STATE OF NEW YORK
PUBLIC SERVICE COMMISSION

Proceeding on Motion of the Commission to Examine Alternating Current Transmission Upgrades	Case 12-T-0502
In the Matter of Alternating Current Transmission Upgrades - Comparative Proceeding	Case 13-E-0488
Application of North America Transmission Corporation and North America Transmission, LLC for a Certificate of Environmental Compatibility and Public Need Pursuant to Article VII of the Public Service Law for an Alternating Current Transmission Upgrade Project Consisting of an Edic to Fraser 345 kV Transmission Line and a New Scotland to Leeds to Pleasant Valley 345 kV Transmission Line	Case 13-T-0454
Part A Application of NextEra Energy Transmission New York, Inc. for a Certificate of Environmental Compatibility and Public Need Pursuant to Article VII of the Public Service Law for the Marcy to Pleasant Valley Project.	Case 13-T-0455
The Part A Application of NextEra Energy Transmission New York, Inc. for a Certificate of Environmental Compatibility and Public Need Pursuant to Article VII for the Oakdale to Fraser Project	Case 13-T-0456

INITIAL COMMENTS OF NORTH AMERICA TRANSMISSION, LLC AND NORTH AMERICA TRANSMISSION CORPORATION ON R

Figure 1 – Multi-circuit tower proposed Knickerbocker-Pleasant Valley, Alternative 2 (115 kV ROW)

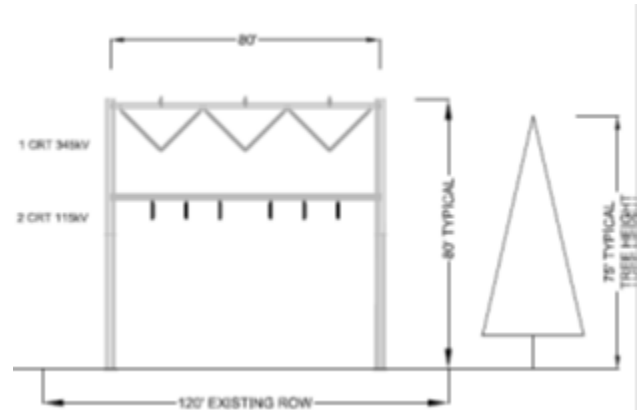
- Adds significant increased transfer capability with a new 345 kV circuit;
- Presents a reasonable cost estimate with significant risk protection to ratepayers;
- Provides minimal electric system impacts with the best reliability on the 115 kV system;
- Requires no new ROW;
- Offers an innovative tower design that meets the criteria of not requiring a wider ROW and being no taller than the existing transmission lines; and
- Minimizes environmental impacts, including visibility impacts, by being within an existing ROW, at the same or lower height as the existing towers.

In contrast, North America's proposed multi-circuit tower design is truly innovative and fits squarely with the evaluation criteria of being an innovation that reduces the physical footprint of the project. North America worked with vendors to identify and develop this multi-circuit tower, which meets multiple difficult design requirements – carrying one 345 kV circuit and two 115 kV circuits, maintaining all necessary transmission line electrical clearances, fitting

within the existing right-of-way, and being no taller than the existing structures. North America is not aware of any other similar tower in operation. At the same time, the underlying H-frame tower technology is commonly used, and this innovative design has very little technology risk.
